STAFF RECOMMENDATION
322 Harvard Ave
July 21, 2021

Application: New Construction - Addition
District: Richland-West End Neighborhood Conservation Zoning Overlay
Council District: 24
Base Zoning: RS7.5
Map and Parcel Number: 104050184.00
Applicant: Van Pond
Project Lead: Jenny Warren, jenny.warren@nashville.gov

<p>Description of Project: New construction of an addition.</p> <p>Recommendation Summary Staff recommends approval with the following conditions</p> <ol style="list-style-type: none">1. The footprint shall not be extended further to the rear;2. Staff review and approve the final windows, doors and roofing color prior to purchase and installation; and,3. The HVAC shall be located behind the house or on either side, beyond the mid-point of the house, and utility meters shall be located on the side of the building, within five feet (5') of the front corner. Alternative mechanical and utility locations must be approved prior to an administrative sign-off on building permit(s); <p>finding that the project meets II.B of the <i>Richland-West End Neighborhood Conservation Zoning District: Handbook and Design Guidelines</i>.</p>	<p>Attachments</p> <p>A: Photographs B: Site Plan C:

Figure 7: Location of the new Breakfast Room, in blue

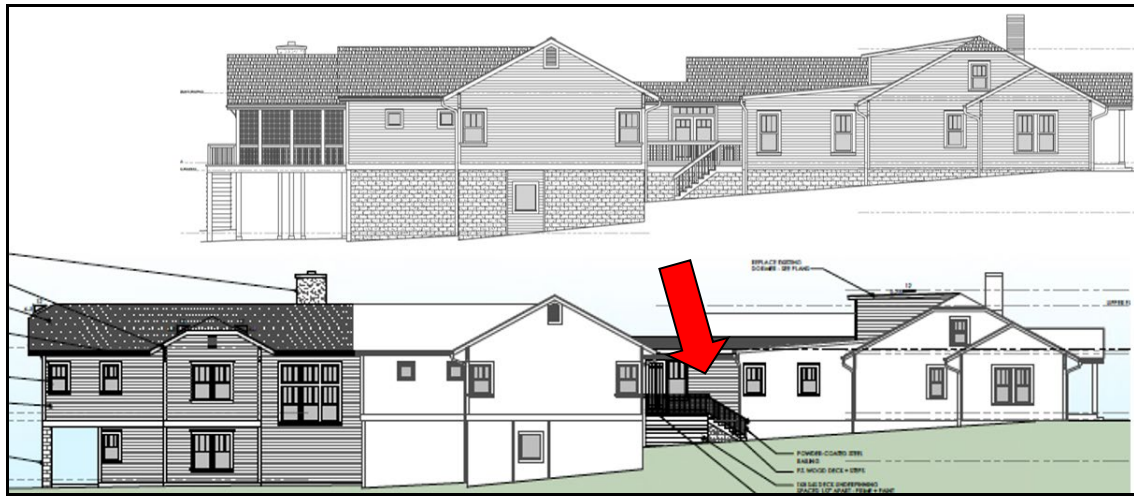
On the left side, a recessed deck area within an existing addition will be enclosed to create a breakfast room. (Figure 7) This work will not increase the height or width of the addition. The side wall will be flush with the existing addition, but as this work occurs beyond the appropriate inset from the original back corner, staff finds this to be appropriate.

PROPOSED
SITE PLAN

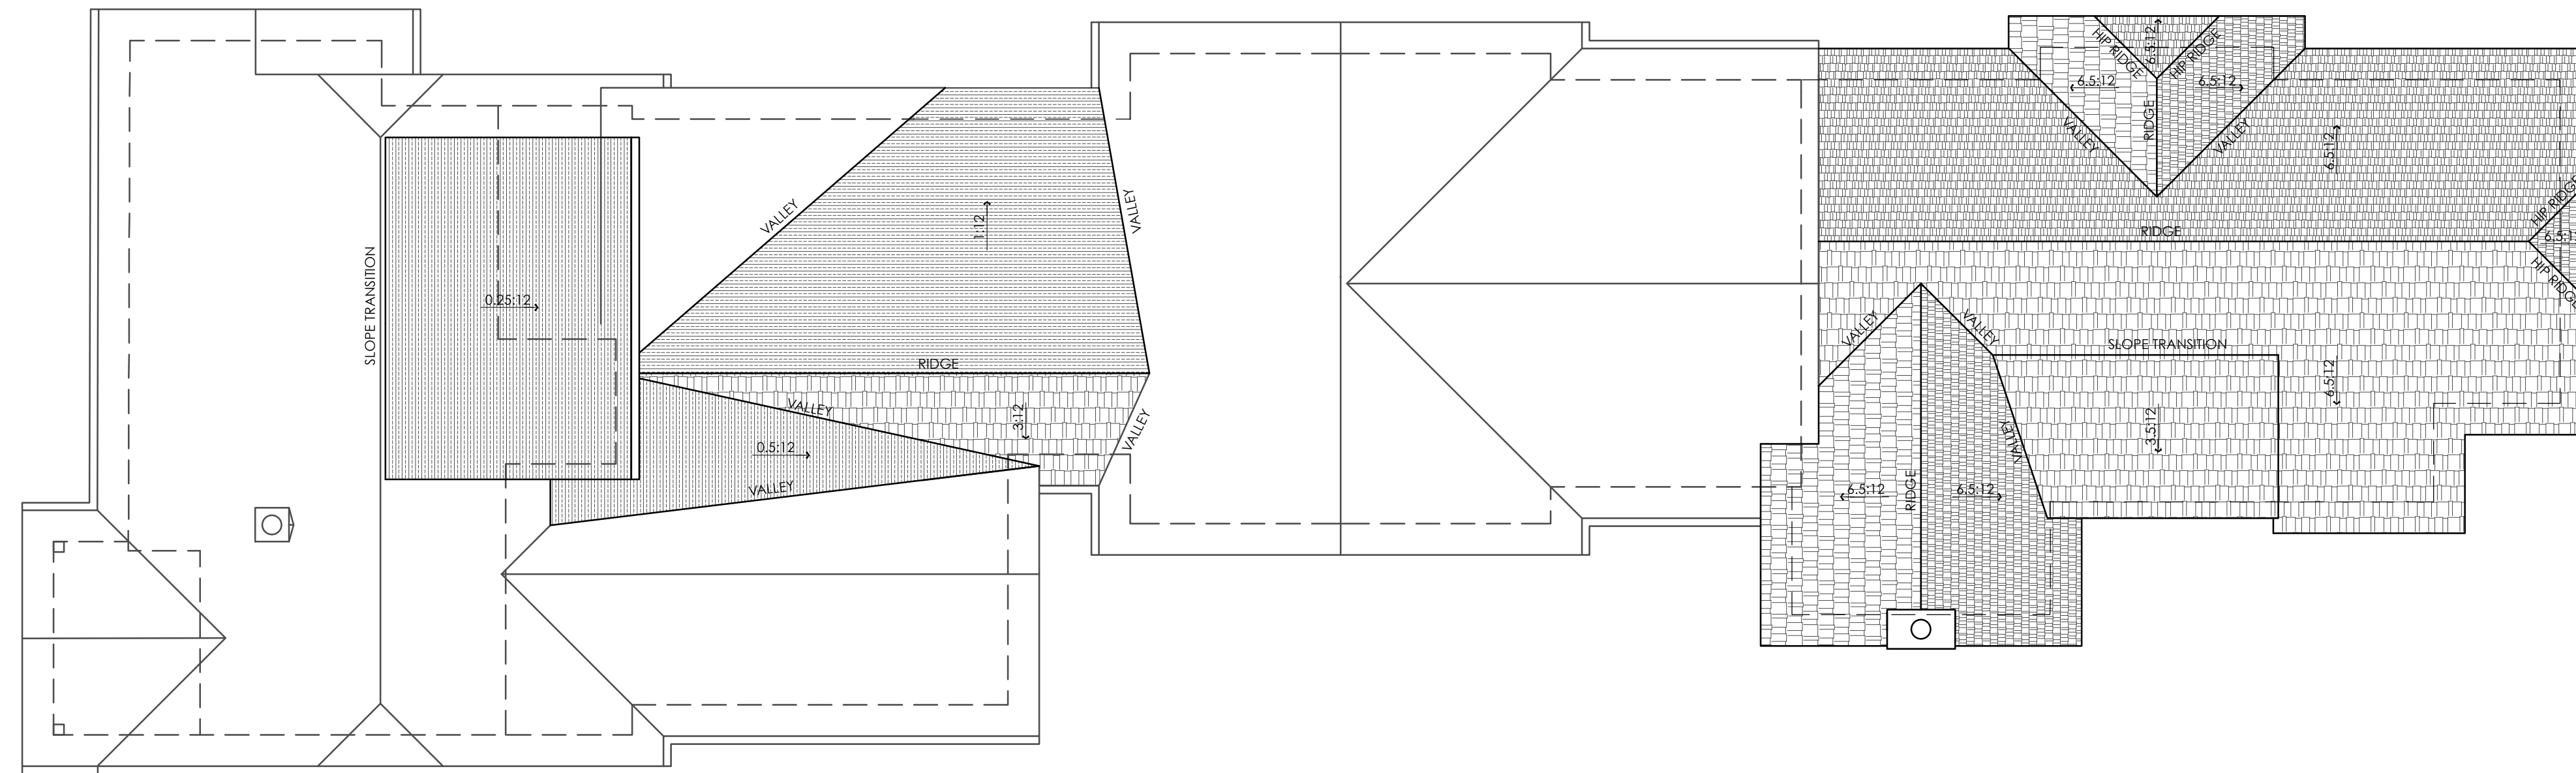
The proposed additional massing - added to a modest historic house that has already nearly tripled in footprint due to prior additions - is not compatible with the scale of the historic house. The design guidelines are intended to allow appropriately scaled additions that are compatible with the original historic houses. The guidelines state that *“No matter its use, an addition should not be larger than the existing house, not including non-historic additions, in order to achieve compatibility in scale. This will allow for the retention of small and medium size homes in the neighborhood.”*

This addition is approximately one thousand-five-hundred-forty-six square feet (1,546sqft) - and the original footprint of the house was again about one-thousand-four-hundred square feet (1,400sqft). The Commission has on occasion approved additions that are slightly larger than the historic house – particularly if the house is very small. This additional square footage on its own might be appropriate if there were no other earlier additions. However, adding additional massing onto a modest historic house that has already been enlarged to a nearly four thousand square foot (4,000sqft) footprint exceeds compatibility in scale. This small-to-medium sized historic house has already been converted into a large home and a subsequent addition will further skew the scale. The majority of this house has now been constructed post-2005.

Staff finds the dormer addition and the breakfast room addition are appropriate, but that the rear addition is not. Some of the existing screened porch could be converted into conditioned space, but extending the footprint further does not meet section II.B.1.a and b. for scale.

1. The footprint shall not be extended further to the rear;
2. Staff review and approve the final windows, doors and roofing color prior to purchase and installation; and,
3. The HVAC shall be located behind the house or on either side, beyond the mid-point of the house, and utility meters shall be located on the side of the building, within five feet (5') of the front corner. Alternative mechanical and utility locations must be approved prior to an administrative sign-off on building permit(s);

PROPOSED SOUTH-WEST + SOUTH-EAST ELEVATIONS

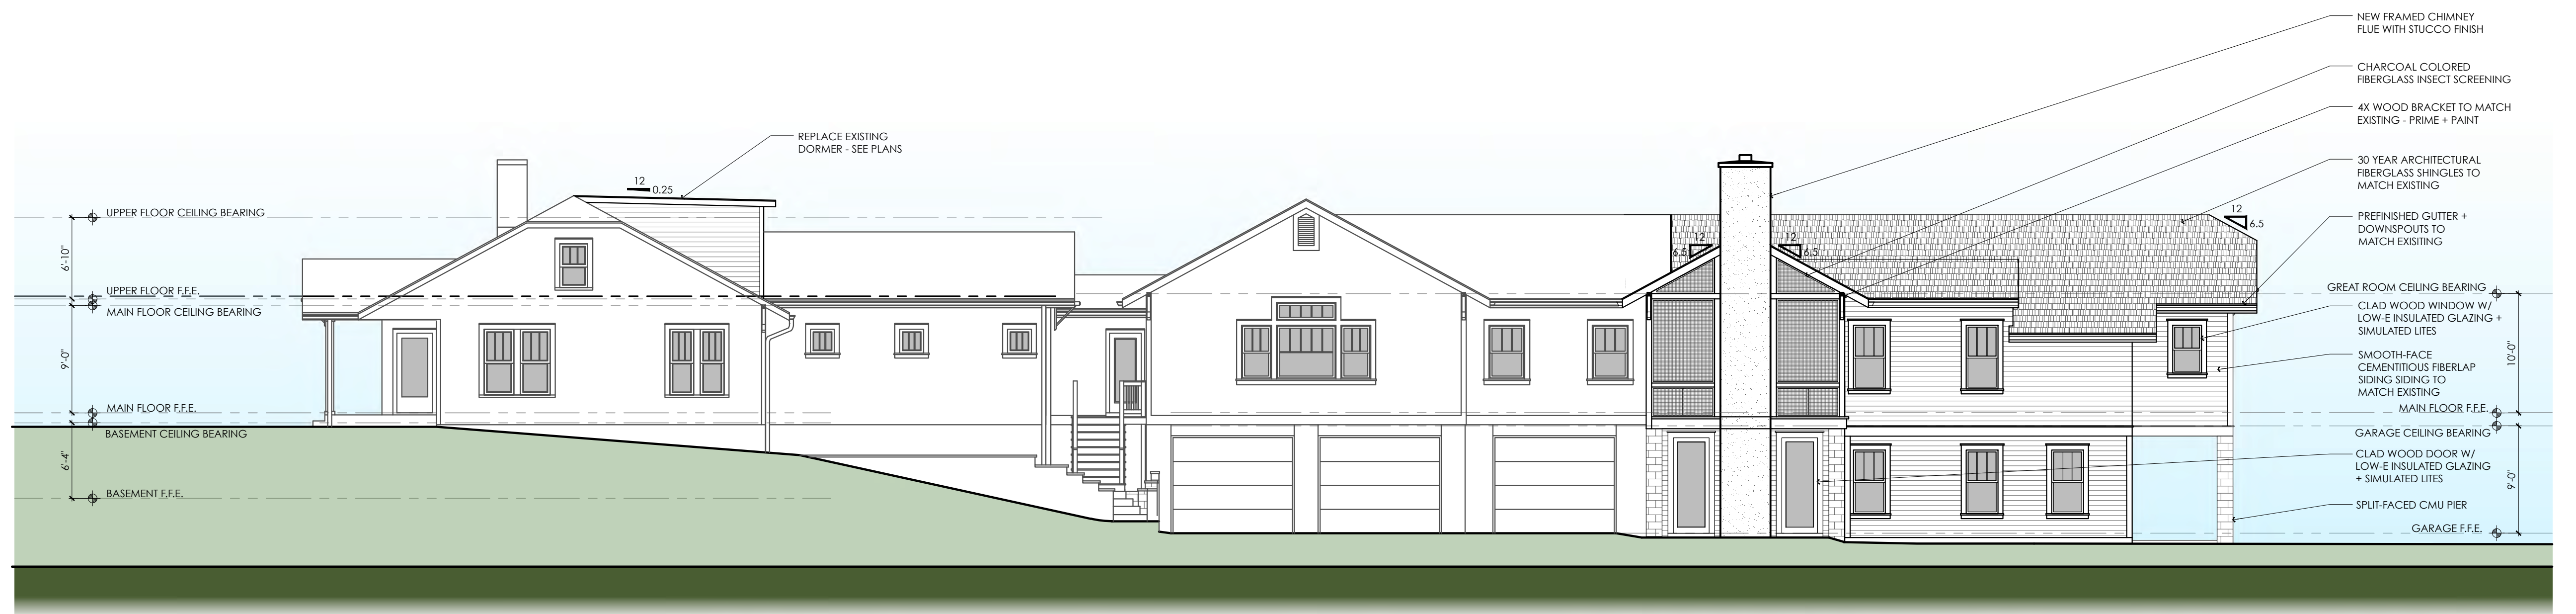
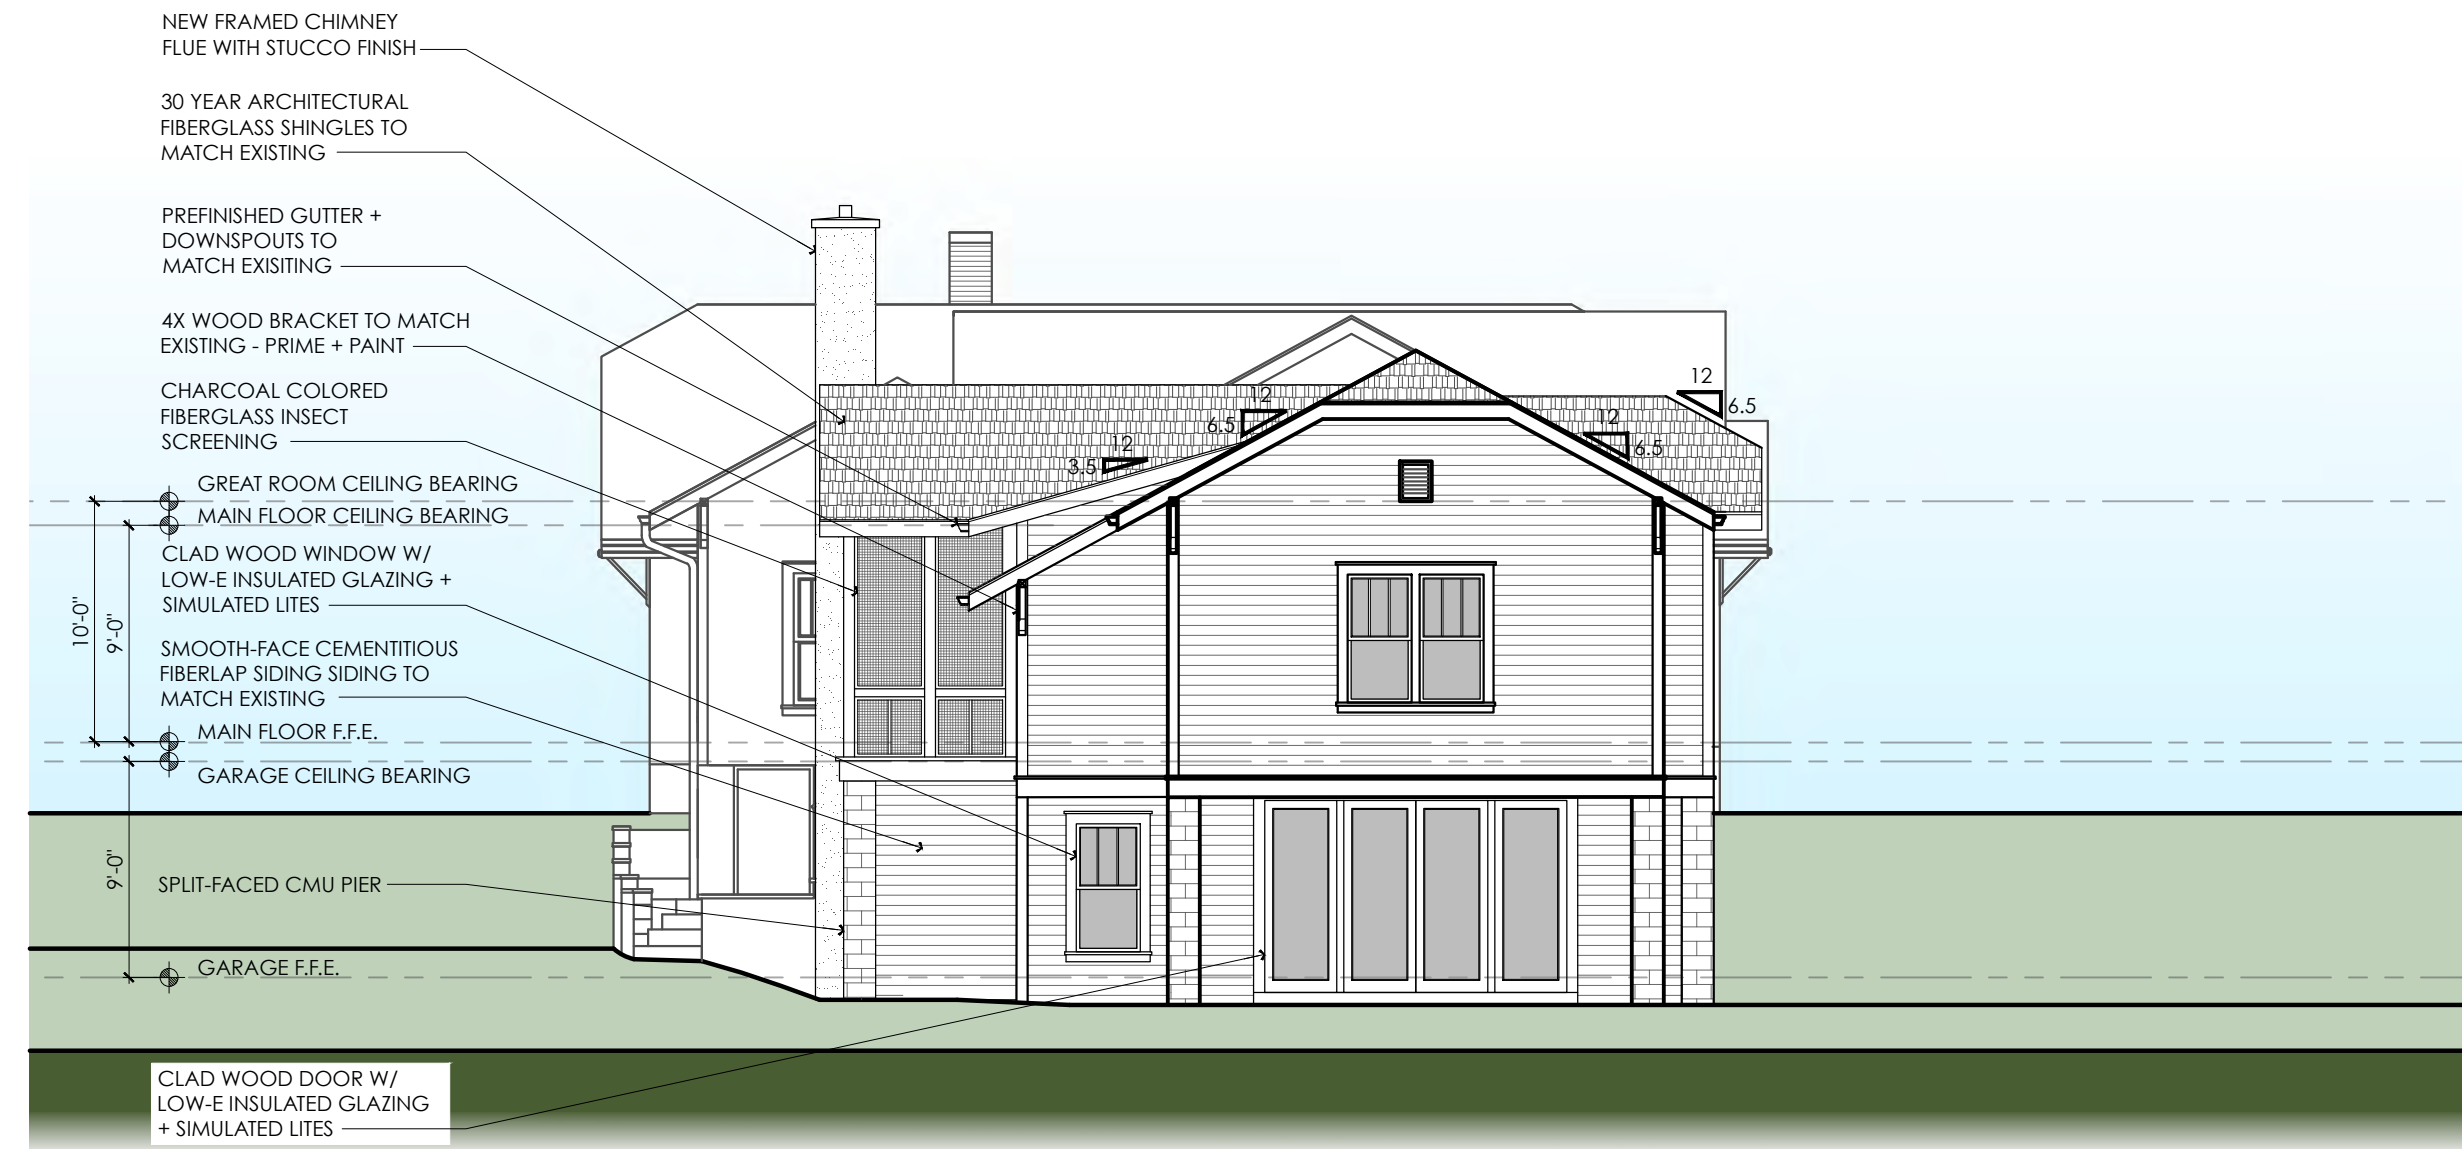
On the rear the existing screen porch will be removed and a new forty foot (48') deep rear addition will be constructed. The addition will continue the main living level, and due to the slope, will add a full-height basement level. See Figures 8 & 9. A screened porch will be added on the right side elevation; it will not step wider than the historic house.

Design: The design of the breakfast room and dormer are compatible with the historic structure. The materials, fenestration, height and overall design of the rear addition is compatible as well, but when combined with the existing additions, the design is too large for the modest historic house.
